SERVICE BULLETIN

Reference:	342-49-049 – SERVICE BULLETIN
Title:	Update of removal and installation procedures following the release of SB 342-49-048
Issue number:	001
Issue Date:	27-apr-2023

This Service Bulletin (SB) is applicable to all APU power plant fitted on Leonardo Helicopters AW189/AW149 helicopters.

Some procedures need to be updated with regard to the new combustor casing design, which modified the locking of the ignition and main manifolds' burners, igniter plugs and drain valve. The impacted procedures, updated in this Service Bulletin, are the following:

Figure 68: Locking of the screws attaching the ignition and main burners if the APU is in post-modification SB 342-49-048 configuration

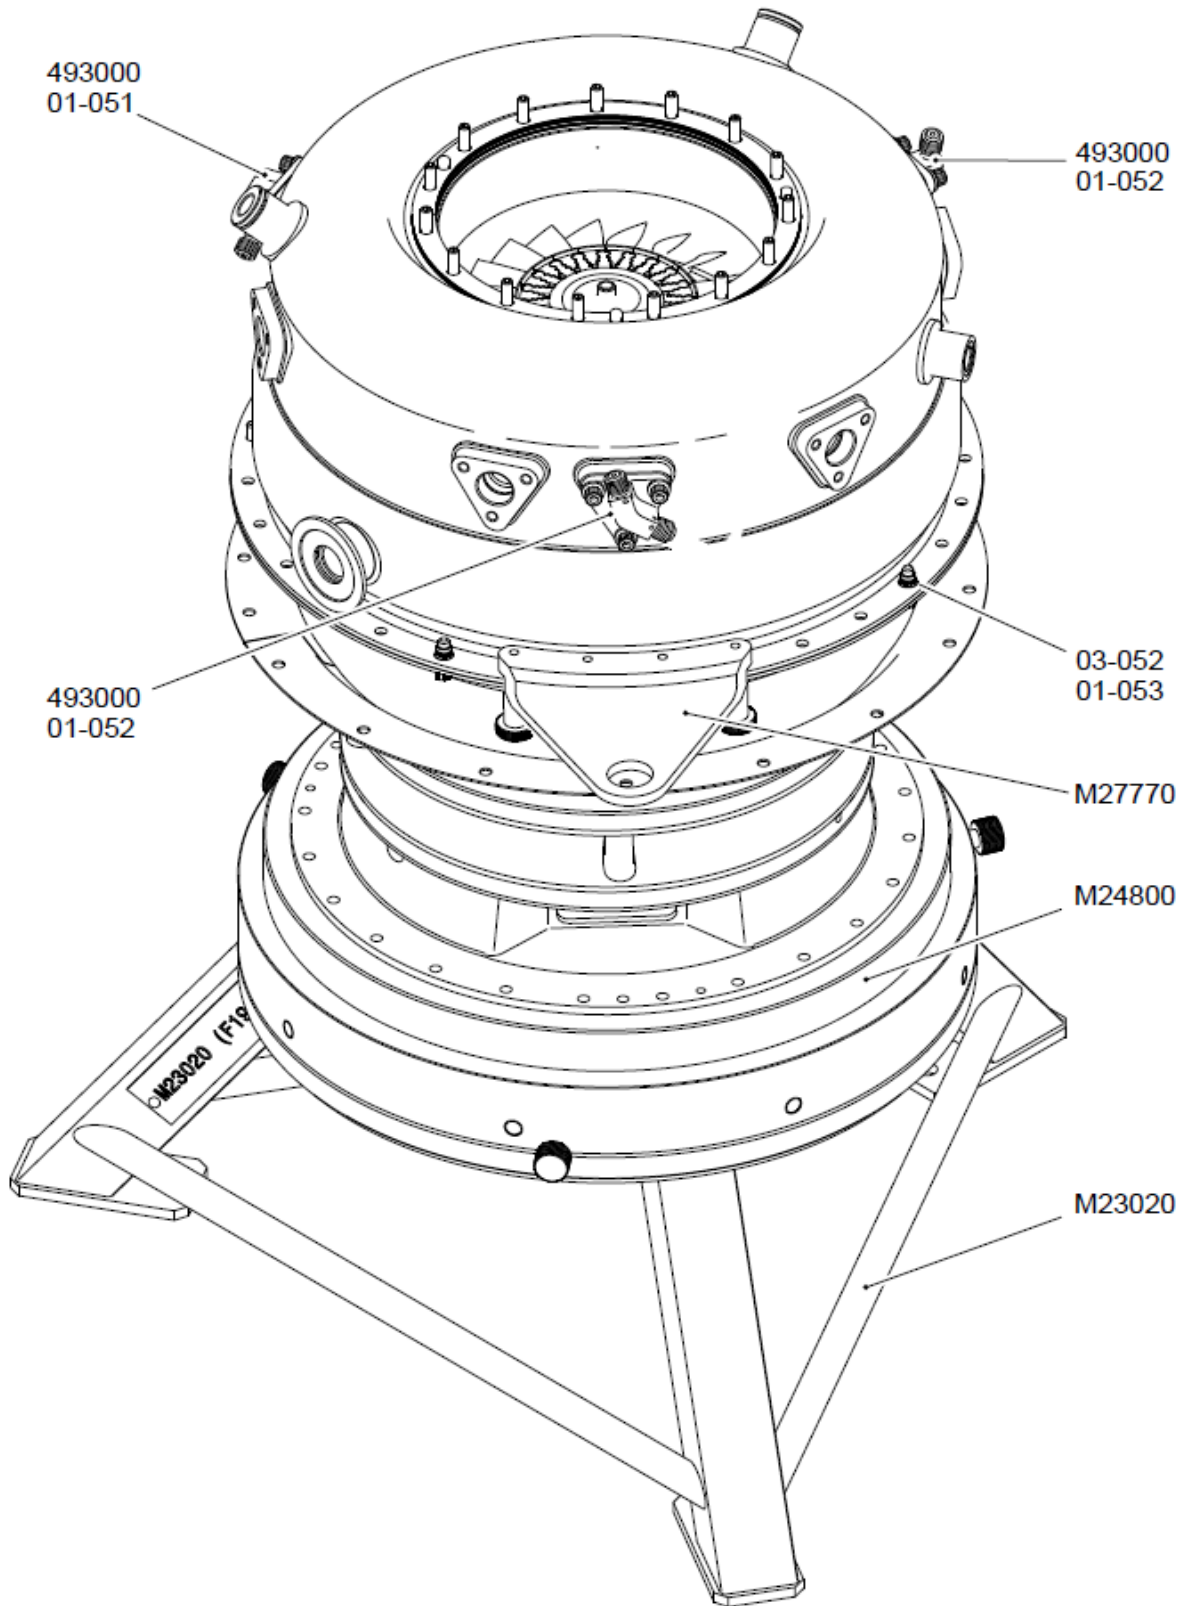
1.35.20 Locking of the ignition and main burners if the APU is a post-modification SB 342-49-048 configuration:

1.35.20.1 Lock the screws attaching the ignition and main burners with Lockwire as shown in the Figure 68.
